# UNITED STATES PATENT AND TRADEMARK OFFICE

### Office Action Summary

10/576,560

HEMMINGSON, OLLE

FIG. 5

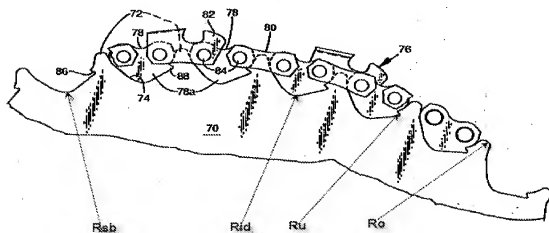
Re claim 1, Carlton discloses disc saw blade 60 with a saw chain 76 mounted around the circumference of a circular disk 70, the saw chain 76 is provided with driving links 78, connecting links 80 and cutting links 82, wherein the chain 76 is guided by means of the driving links 78 in at least one chain groove. It should be noted that the groove is formed by plates 66, 68, and disc 72 per Fig.4 as explained in col. 3, lines 43-46. Carlton also discloses that the chain 76 is arranged around the periphery of the disk 70, against the bottom 74 of the groove, a part 78a of each driving link that projects radially inwards can make contact, in that the bottom 74 of the groove has radial projections 86 distributed around the circumference and the driving link has a cam surface 88 on the part 78a that projects radially inwards for interaction with the respective radial projection 86, and in that the chain 76 can move from a neutral position, in which the chain is loosely mounted around the circumference of the disk 70 and the part 78a of the respective driving link 78 that projects inwards is loosely inserted between two adjacent radial projections 86, to a working position, in which the chain is

tensioned around the circumference of the disk 70 and the cam surface 88 on the respective driving link is in contact with the associated radial projection 86 per Fig. 5.

Re claim 2, Carlton discloses that the cam surface 88 on each driving link 78 is designed to press the chain 76 radially outwards against the radial projection 86 by the cam effect, in such a way that, in a tensioned state, the chain is held onto the disk 70 as a result of its shape per Fig. 5 and per col. 4, lines 3-36.

Re claim 3, Carlton discloses that the length of the saw chain 76 is matched to the radius  $r_o$  of the disk 70, so that, when the saw chain is mounted, a radius  $R_{id}$  to the part 78a (bottom portion) of each driving link 78 in the chain that projects radially inwards is larger than a radius  $R_{sb}$  to the bottom of the groove 74 and less than a radius  $R_u$  to each projection 86 per modified Fig. 5 shown above. It should be noted that the equivalent markings of the radii is performed to clarify the understanding of relationship amongst various radii. As 78a portion of the driving link fits into the gully

area 74 of the disc 70, it is apparent and inherent that area of the portion 78a is smaller. Hence, the  $R_{id}$ , distance of the bottom portion of 78a to the center of the disc 70, is greater than the  $R_{sb}$ , the distance of the bottom (valley) portion of the gully 74 with respect to the center of the disc 70.

Re claim 4, Carlton discloses that the bottom 74 of the groove has a predetermined number of projections 86 distributed evenly around the circumference of the disk 70 per Fig. 5.

Re claim 5, Carlton discloses that the bottom 74 of the groove has one projection 86 for each driving link 78 per Fig. 5.

Re claim 6, Carlton discloses that radial cross-section of each projection 86 is lug shaped per Fig. 5.

Re claim 7, Carlton discloses that radial cross-section of each projection 86 is pyramid shaped per Fig. 5.

Re claim 8, Carlton discloses that radial cross-section of each projection 86 is dome shaped per Fig. 5.

Re claim 9, Carlton discloses that radial cross-section of each projection 86 is designed as a truncated cone that has a complementary shape to the cam surface 78a of the interacting driving link 78 per Fig. 5.
